Touchstones Cultural Hub

Supplementary Planning and Conservation information

13/10/2023

1. Fire Escape Viability Analysis

Option 4 – Next to the river

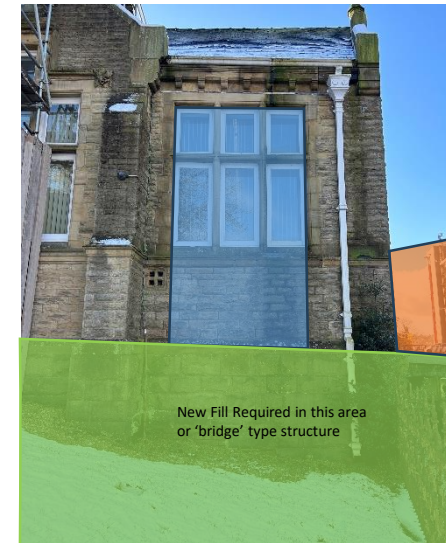
The team understands how the bay to the far right hand side would be the least visible position for the escape door, however this is unfortunately not possible due to the business planning, structural engineering, programme and cost reasons highlighted:

New Fill Required in this area
or 'bridge' type structure

Extension to
railing required

Extension and
reinforcement
to retaining wall
required

- The window detailing to this bay is the same as to the far left hand bay (the previously selected location), however the formation of a door opening in this location is not comparable to the selected location. This is due to the fact that the elevation terminates on the river wall and as noted in the accompanying SE response from Sutcliffe, the existing top of river wall datum level is approx. 122.20m AOD whereas the ground level of the building is 124.00m AOD. Due to this difference in levels of 1.8m creating an escape in this location either requires very significant engineering works to the river wall or the creation of a cantilevered structure with the aim to mitigate works to the river wall.

- From both an engineering and a heritage perspective there are a large number of significant unknowns regarding proposing a solution that would require works to the river wall. The existing construction is very unlikely to have been designed to a standard that will comply with current standards and required calculations. This is not currently known and not possible to determine without undertaking intrusive investigation works to the river wall. However based on experience of working with Victorian infrastructure of this nature the team anticipate that any works to increase the height of the river wall would not be possible without significant remedial engineering proposals such as significant rebuilding / strengthening and / or underpinning. The unknowns pose too high a risk to the project for this to be recommended as an option to proceed with.

- The alternative of providing a cantilevered structure also holds significant concerns in relation to the potential additional physical impact that the provision of the necessary support would require (over and above the creation of the door opening). This is detailed in the accompanying SE response.

Door Design

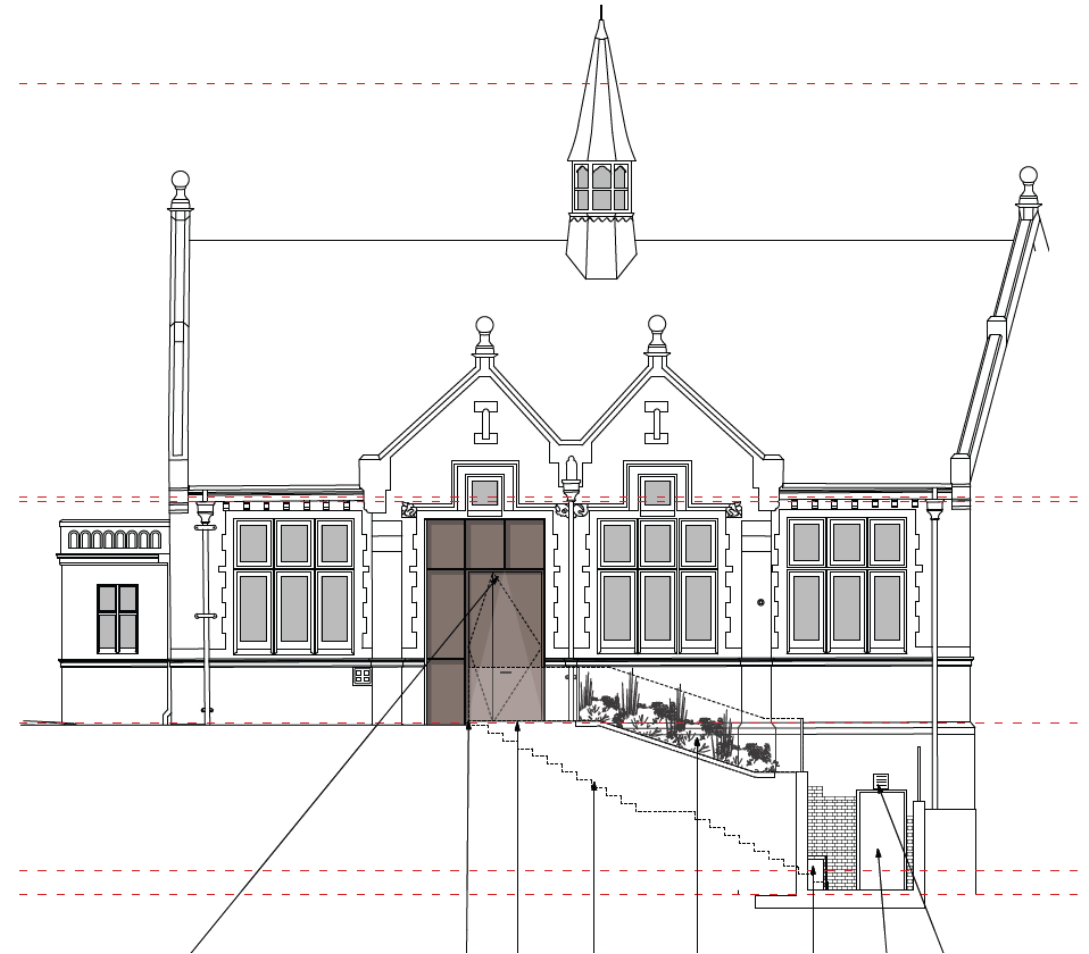
The team have been asked to explore whether this can be glazed.

Unfortunately, due a high level of security is needed due to the works contained within the building. This concern has also been exacerbated by a recent uplift in break-ins within Rochdale Town Centre, including at the recently completed Richard Street artist studios, and the Fireground Café, both of which have utilised glazed doors to break in and gain entry.

Unfortunately neither the basement or ground floor doors are able to accommodate a security lobby without severely impacting on the spaces within, and in the case of the fire escape from the performance space, significantly:

We have therefore concluded this is not viable.

It is also important to not that from an aesthetics perspective it is not possible to replicate the exact proportions of the original window within the doors themselves as one of the door leafs must be sized appropriately to allow a wheelchair through it. Therefore this option whereby the door is solid is also the best approach. As the door is solid the surrounding area should also be solid, otherwise the windows would look odd and the door would stand out more than is necessary.

The proposal therefore utilises a high quality bronze coloured metal door which references the proportions of the existing mullions and the materials used in the original building, whilst achieving these security requirements.

Questioning the need and location of the quiet space

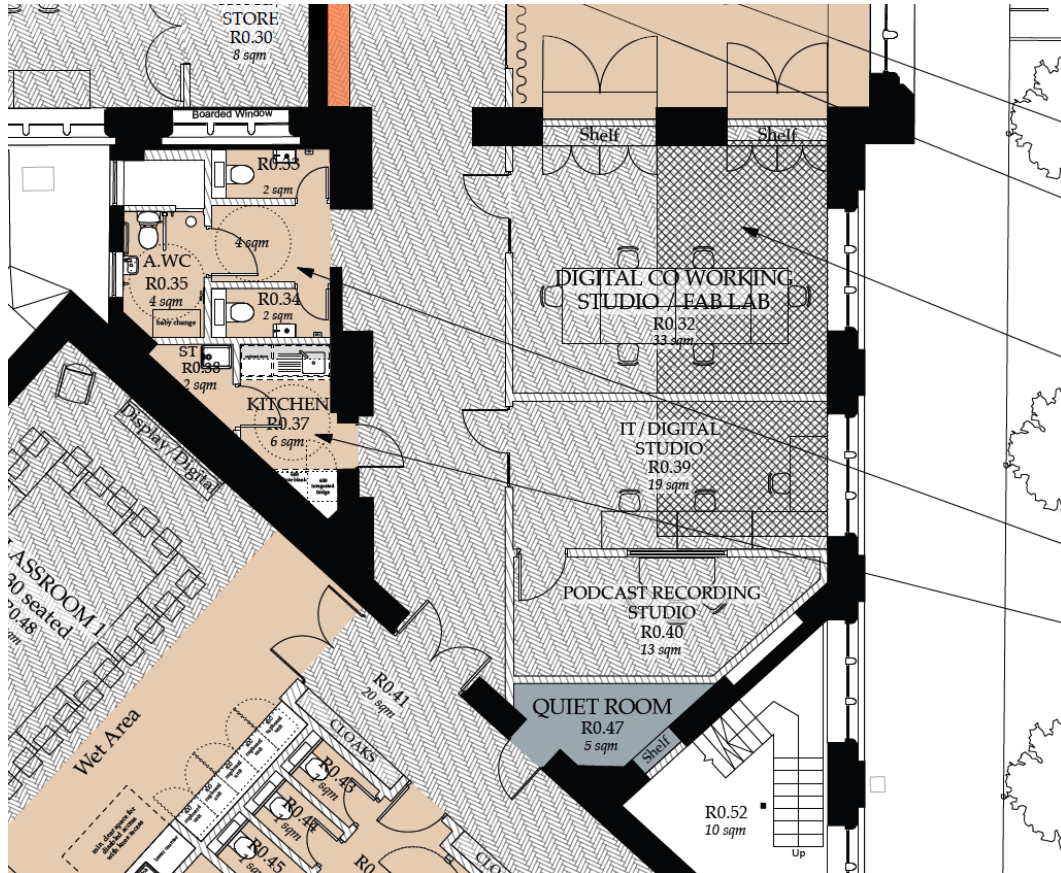
Following submission of the planning application 08/06/2023 – the conservation and planning officers have asked the client, user and professional team to question the necessity of the quiet space, due to concerns about the creation of the new entrance into this space, and the partition needed to separate this from the podcast space next door. The extensive interrogation of the need and location of this space is summarised below:

As highlighted on the previous page, there are a number of facilities that need to be accommodated within the 'secure zone' needed for child safeguarding, including WCs and storage to replace the large quantum lost in order to remove the shelving that currently covers 6 of the 7 stained glass windows. The user team have interrogated the necessity for each space within the secure zone and advised that there are none that can be removed in order to allow the quiet space to be relocated. The space proposed for the quiet space in the application maintains the position of the quiet space in the 'secure zone', but has the added benefit of being outside outside of the classroom box and therefore giving more physical and acoustic isolation from the classrooms. Whilst its not visibly noticeable from the plans, the location proposed has a much greater headroom than the only alternative (the box containing the WC's and store). Both of these considerations will improve the experience of this space for those needing it.

For these reasons, and the very limited impact of this preference on this historic building fabric, the team have concluded the quiet space needs to remain in the location proposed in the application. The team also conclude that when viewed in the full context of the other proposed changes to the education space, which include uncovering all the boarded up windows and removal of poor quality insertions, the proposal represents a significant net improvement in how the heritage of the space is experienced and preserved. The localised impact is a relatively minor and unnoticeable, yet will significantly improve the experience for neurodivergent children needing to use the space and therefore deliver significant community benefit.
